| Request | - | Special Use Permit for a School |
| Location | - | 1501 N Ontario Street |

SPECIAL USE PERMIT
TOLEDO CITY PLAN COMMISSION

REF: SUP-4001-24

SITE PLAN

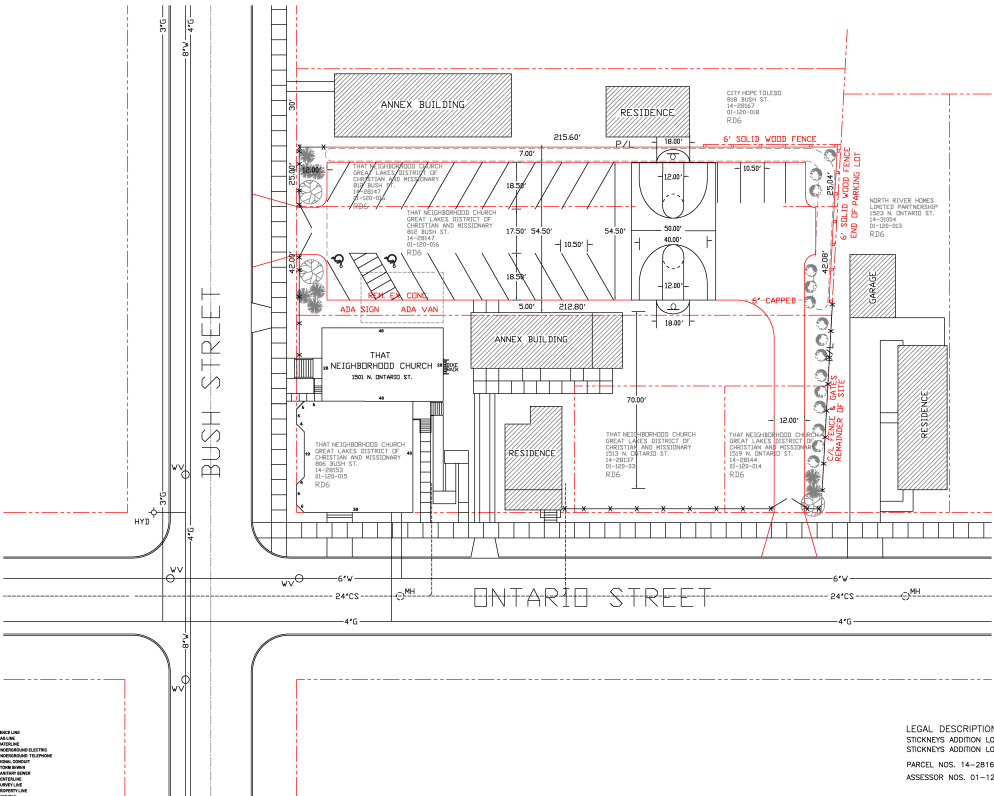
Circulation through the site will remain the same as it currently exists with an ingress-only drive off Bush Street and an egress-only drive off Ontario Street. TMC§1107.0300 *Off-street parking Schedule "A"* requires a minimum of three (3) off-street parking spaces for the proposed school and a minimum of twelve (12) off-street parking spaces for the existing church. The applicant proposes to keep the site's existing 23 off-street parking spaces. The parking is compliant, but at the maximum allowed. TMC§1107.0302 *Maximums* states that no use may provide more than 150 percent of the minimum.

The applicant has provided two accessible parking spaces – one more than is required by TMC§1107.1700. These spaces must be identified with signs and pavement markings reserving them for persons with disabilities. Signs must be posted directly in front of the parking space at a height of no less than 60 inches and no more than 72 inches above pavement level.

A minimum of one (1) bicycle space per ten (10) automobile parking spaces plus one (1) bicycle space per three (3) students is required pursuant to TMC§1107.0300 *Off-Street Parking Schedule "A"*. The site plan provides five (5) bicycle parking spaces. Thirteen (13) are required.

A landscaped frontage greenbelt is required along all public rights-of-way. At least one tree must be provided for every thirty feet (30') of lot frontage, rounded up. The lot has ±144 feet of frontage on Bush Street and ±207 feet of frontage on N Ontario Street, requiring five (5) trees and seven (7) trees respectfully. The site plan provides two (2) trees along Bush Street and one (1) tree along N Ontario Street. The Plan Director agrees to waive this requirement down to three (3) trees due to the existing buildings abutting the rights-of-way of Bush and Ontario Streets.

A perimeter landscape buffer is required along any parking lot area adjacent to a street, place, or driveway, or which is visible from an immediately adjacent property. On this site, a perimeter landscape buffer is required along the eastern property line and portions of the northern property line. A perimeter landscape buffer is not required adjacent to 818 Bush Street due to the property being used by the Church in an accessory manner. The perimeter landscape buffer must contain a minimum of one canopy tree for each 30 linear feet, plus a continuous row of shrubs with a minimum height of 18 inches. Privacy fencing may substitute for the shrub requirement per TMC§1108.0203(D)(2). The perimeter provides shrubs along most of the eastern perimeter and a six-foot (6') solid fence in the remaining areas. A minimum of seven (7) trees are required in the perimeter landscape buffer. Only four (4) are provided; however, one of the provided trees is existing and has an estimated caliper of twenty-one inches (21"). Per TMC§1108.0407 *Tree Preservation and Credit For Existing Landscape Materials*, this existing tree may count as six (6) trees towards the tree quantity requirement. The proposed perimeter landscape buffer is acceptable as depicted.

18. Wheel stops are required at all parking spots abutting sidewalks, property lines, planting areas and buildings per TMC 1107.1907.
19. Existing curb cut and drive approach that is no longer being utilized near exit drive on Ontario must be removed and replaced with new curb and grass to match adjacent areas.
20. Existing broken sidewalk on Ontario Street and Bush Street must be removed and replaced to match adjacent sidewalk areas.
21. Painted ground signs are required to help prevent wrong way traffic flow.
22. "Do not enter" signage is required at driveway exit on Ontario Street to prevent wrong way traffic flow.

23. Off-street parking shall be provided pursuant to Off-Street Parking Schedule "A," (TMC§1107.0304). A total of fifteen (15) parking spaces are required for this site. The submitted site plan shows twenty-three (23) parking spaces. The site may not provide more than twenty-three (23) parking spaces (150% of minimum). **Acceptable as depicted.**
24. Bicycle parking slots shall be provided pursuant to Off-Street Parking Schedule "A," (TMC§1107.0300). Minimum number of bicycle parking slots required is thirteen (13). **Not acceptable as depicted. Additional bike rack must be installed.**
